Network Working Group
Request for Comments: 1151
Updates: RFC 908

Version 2 of the Reliable Data Protocol (RDP)

This RFC suggests several updates to the specification of the Reliable Data Protocol (RDP) in RFC-908 based on experience with the protocol. This revised version of the protocol is experimental.

RDP Header Format
Figure 1

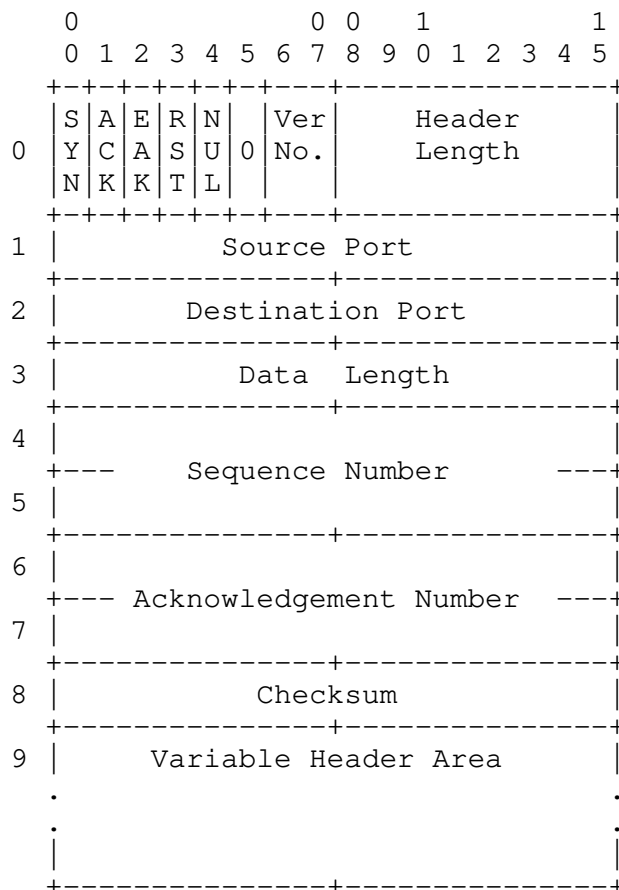
There are three changes to the protocol header: the checksum algorithm has been changed, the port size increased, and the version number incremented. The new header format is shown in Figure 1.

The major discovery during the testing of the protocol is that cost of computing the the RDP checksum proved surprisingly variable; its performance was more heavily affected by the host's data representation than anticipated. Optimized checksum implementations on two comparable hardware bases gave performance that differed by a factor of five. Since the speed of the checksum is a key factor in the performance of the protocol itself, this variation caused a noticeable difference in throughput.

The wide variation in performance on comparable machines was felt to be undesirable, so the checksum has been changed. RDP now uses the 16-bit TCP checksum, which is specified on page 16 of RFC-793.

The 8-bit port size is probably too small to support a large range of applications. Accordingly, the port size is now 16-bits. Port numbers less than 1024 are reserved for well-defined applications. Allocable ports begin at port number 1024.

Finally, because the checksum and port size have been changed, the version number has been increased to 2.
